Nagpur Metro Rail Project - Phase 2

Corrigendum-I

Tender No: N2-010/C-04/2023 dated 07-Sep-2023

Name of Work: Design and Construction of Elevated Metro Viaduct of length 5.333 km between Ch. (-)289.668 m to Ch. (-)5622.577 m in Reach 4A of NMRP Phase-2

TITLE: MS RAILING (SHEET-2)

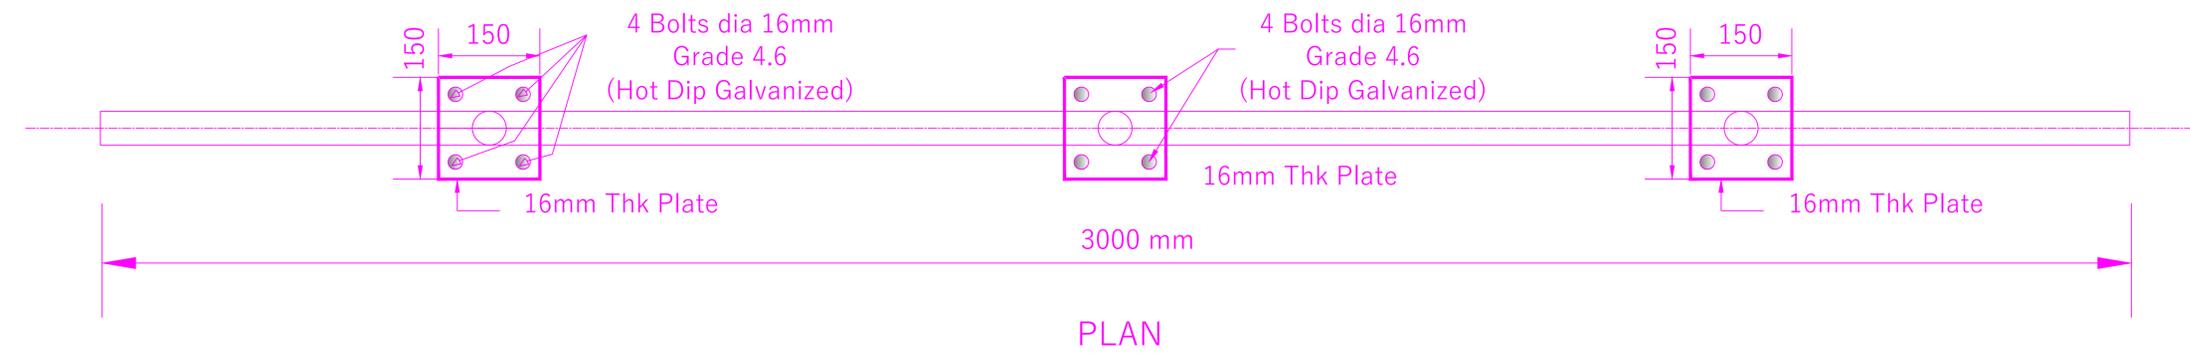
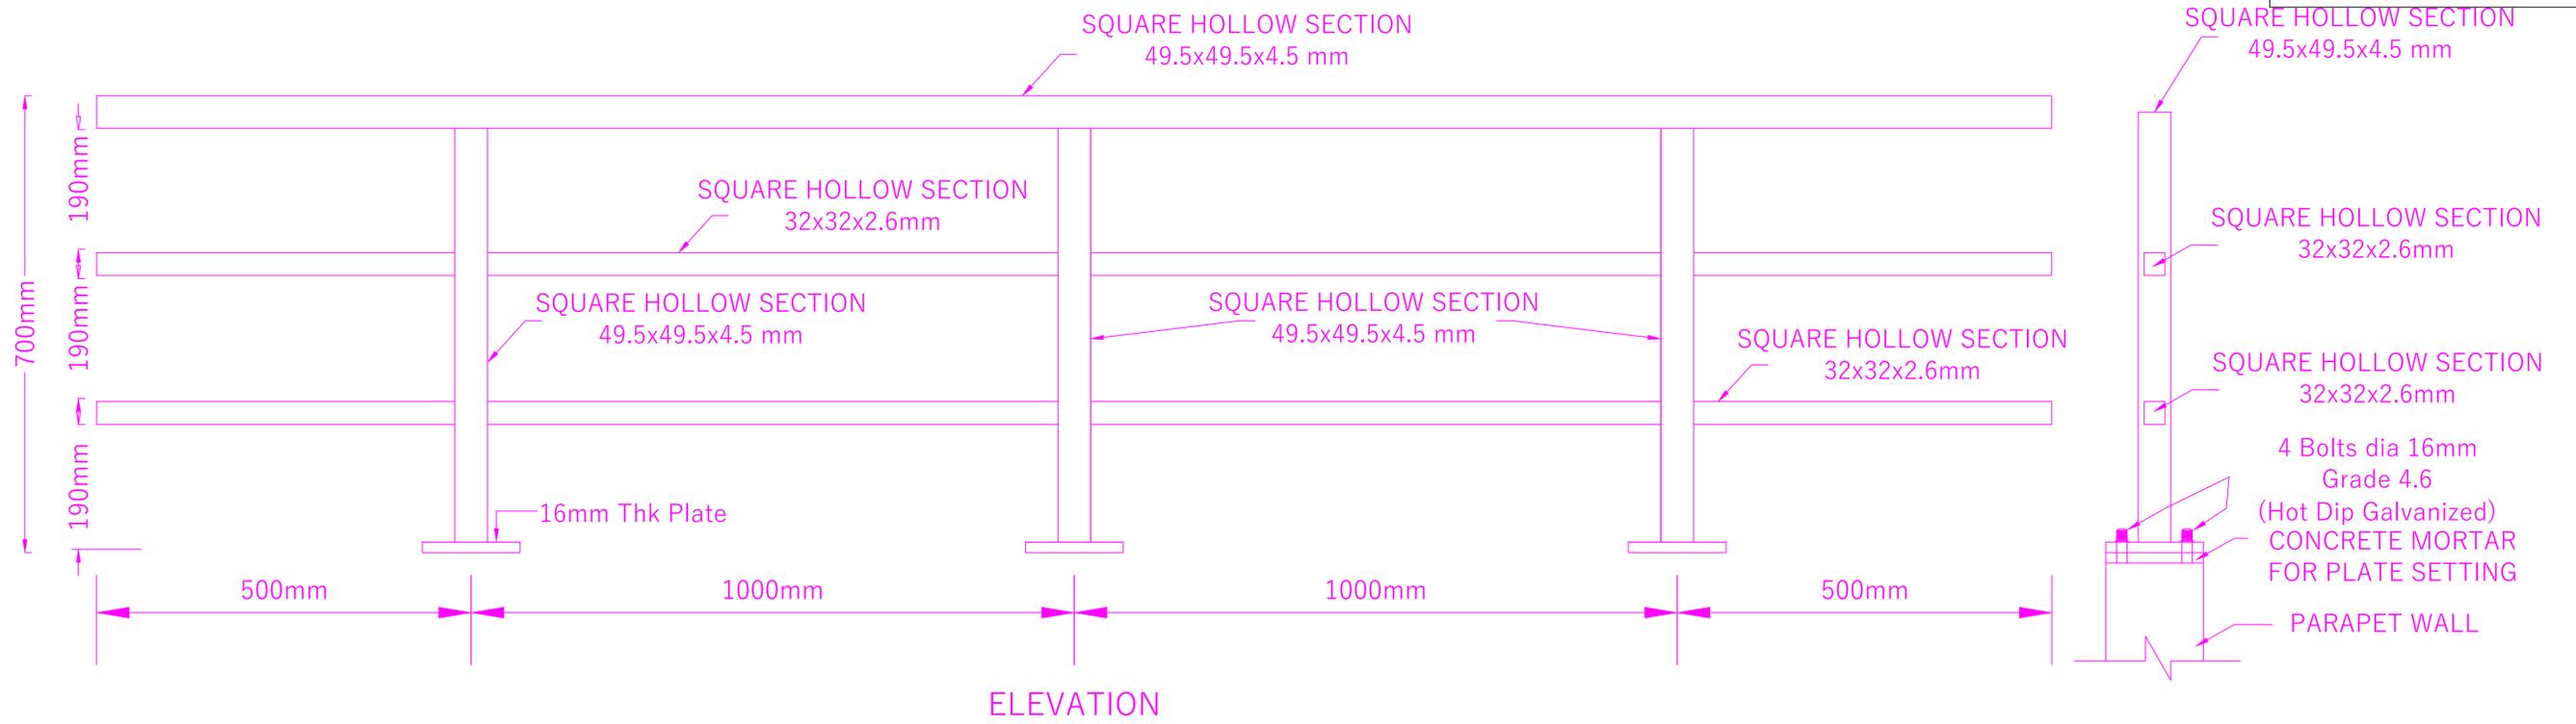
REV NO	DATE	DESCRIPTION	SIGN
R3	11.08.2023	SECTIONS AND FINISHING MODIFIED

TITLE: MS RAILING (SHEET-3)

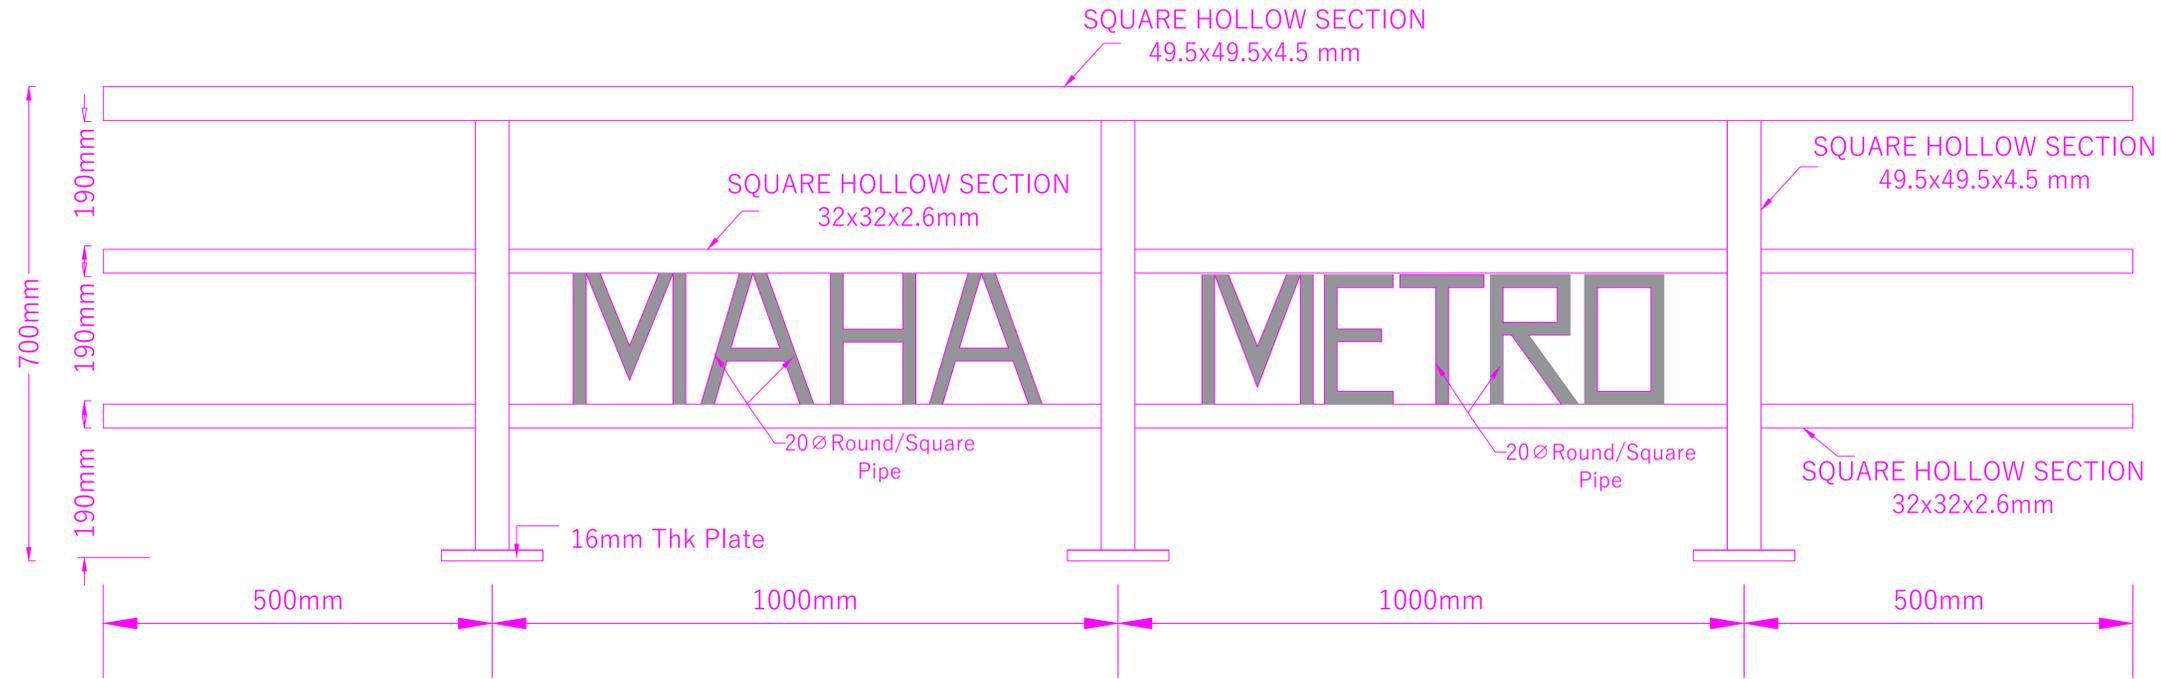
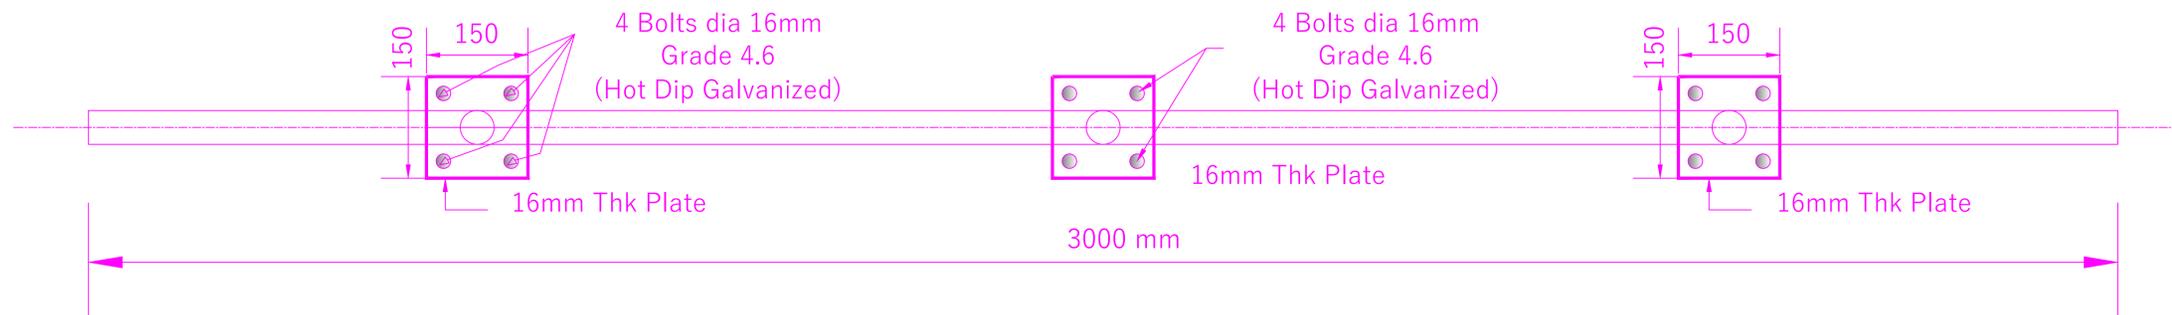
REV NO	DATE	DESCRIPTION	SIGN
R3	11.08.2023	SECTIONS AND FINISHING MODIFIED

TITLE: MS RAILING (SHEET-4)

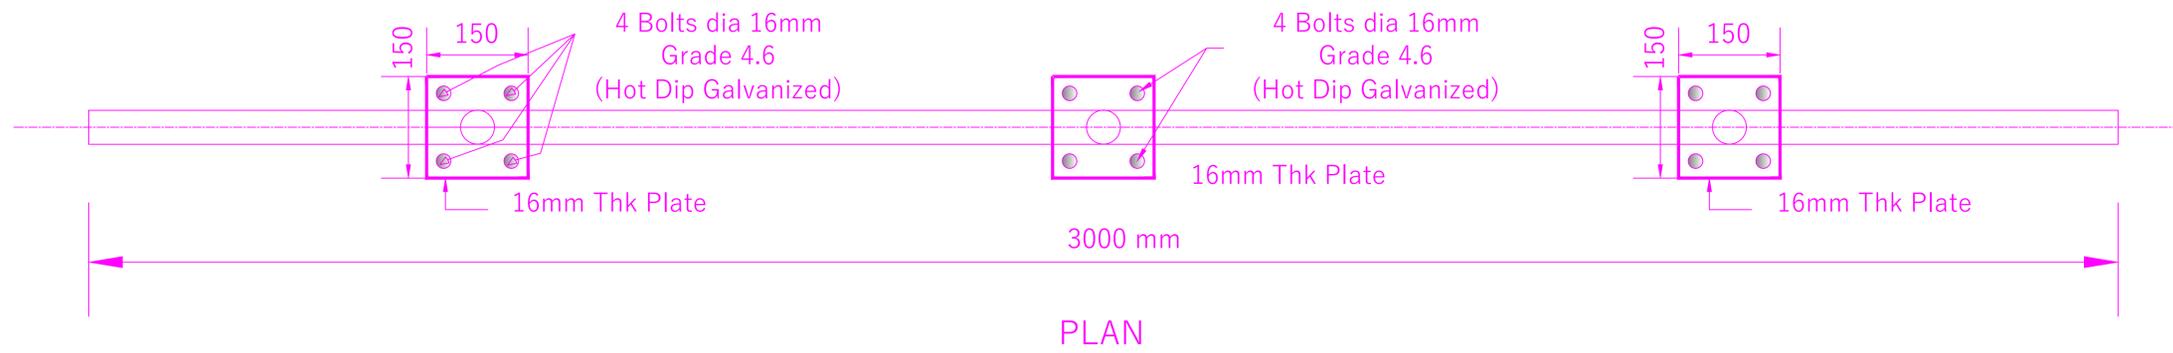
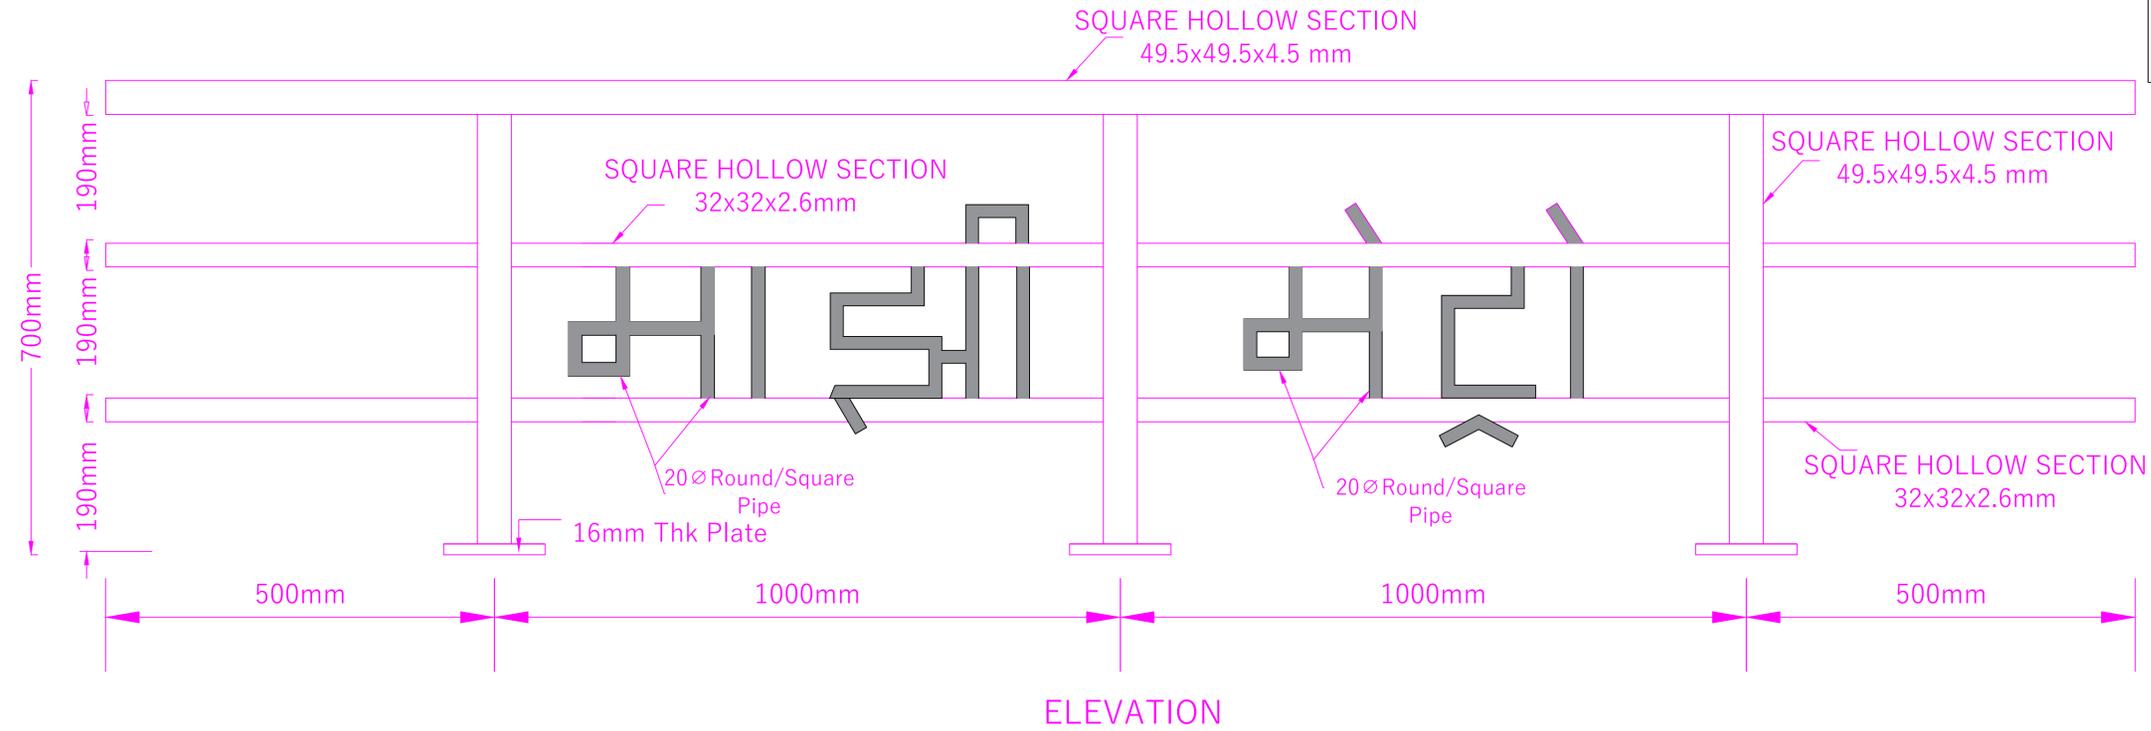
REV NO	DATE	DESCRIPTION	SIGN
R3	11.08.2023	SECTIONS AND FINISHING MODIFIED
